MONTGOMERY COUNTY HISTORIC PRESERVATION COMMISSION
STAFF REPORT

Address:	5 Columbia Ave., Takoma Park	Meeting Date:	1/23/2019
Resource:	Contributing Resource Takoma Park Historic District	Report Date:	1/16/2019
Applicant:	Annie Kneedler & Sam Bryson	Public Notice:	1/9/2019
Review:	HAWP	Tax Credit:	partial
Case Number:	37/03-19A	Staff:	Dan Bruechert
Proposal:	Building Rehabilitation, New Windows, and Building Additions

Figure 2: Image from 1927 Sanborn map with arrows pointing to the bathroom addition and 1-story rear addition by 1927.

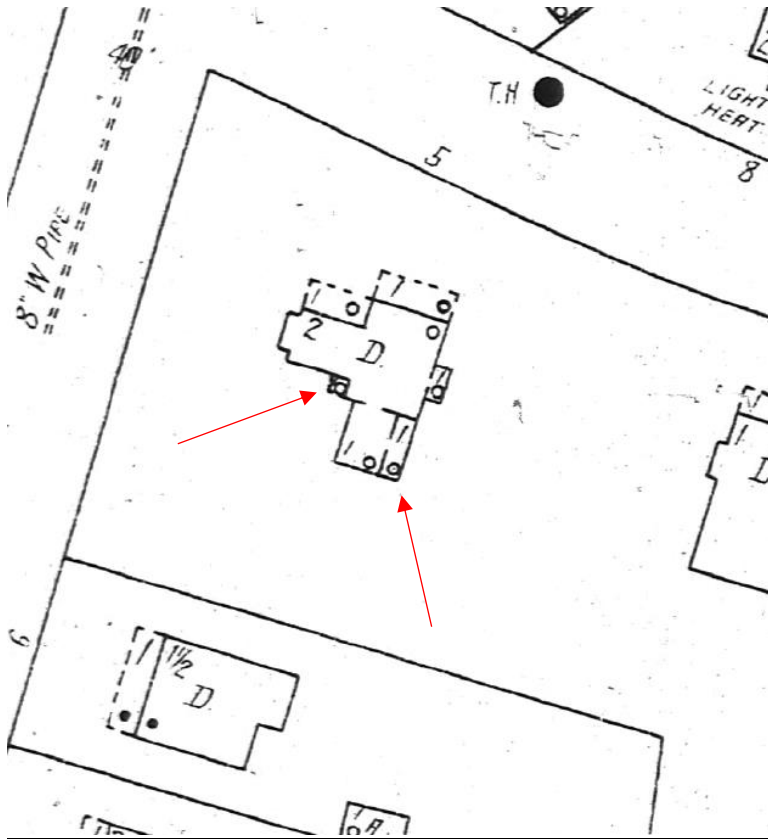
The second rear addition is a shiplap-sided, two-story addition that appears to have been modified over time. The 1927 Sanborn map (below) shows that there were two one-story additions in this location. The second story was not added until after 1959 based on the Sanborn maps which show a consistent footprint at the rear. Based on the appearance of the siding, at least one south-facing window has been boarded over. The second-story of the addition has a pent roof, as does the shorter one-story section to the east. The cornice on the west wall of the rear addition has wood corbels that match those on the historic massing of the house. The south and east elevations lack the decorative cornice. The project architect has informed Staff that:

2 EXISTING FIRST FLOOR PLAN
1/4" = 1'-0"

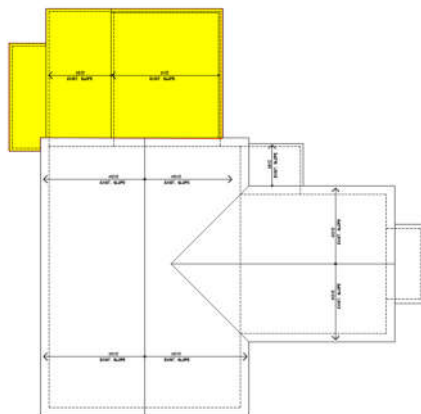
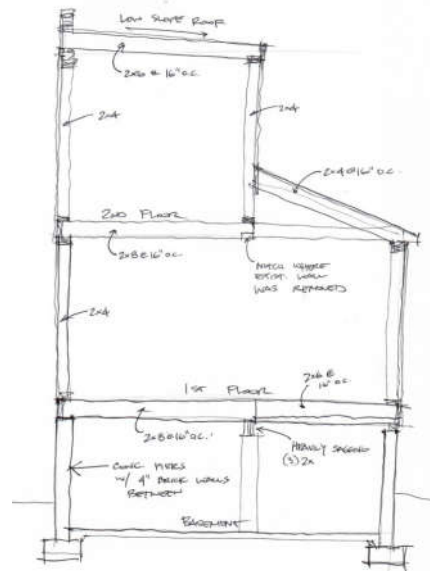
The following letter is to address the structural integrity of the prior existing addition to the historical district home located at the above reference address. The floor plans referenced below are highlighted yellow to show the extent of the addition in question. Also include below is a cross section of the existing addition for reference.

There are major structural concerns in the basement. The masonry basement walls and piers are showing significant signs of deterioration and large cracking.

Much of the existing framing is showing significant signs of water damage and deterioration

The basement slab on grade shows signs of settlement and extensive cracking.

Based upon the above observation, it is in my profession opinion that the existing addition should be removed and replaced. When demolishing the addition, care should be taken to not damage the original existing structure. Should there be any questions or concerns feel free to contact me.
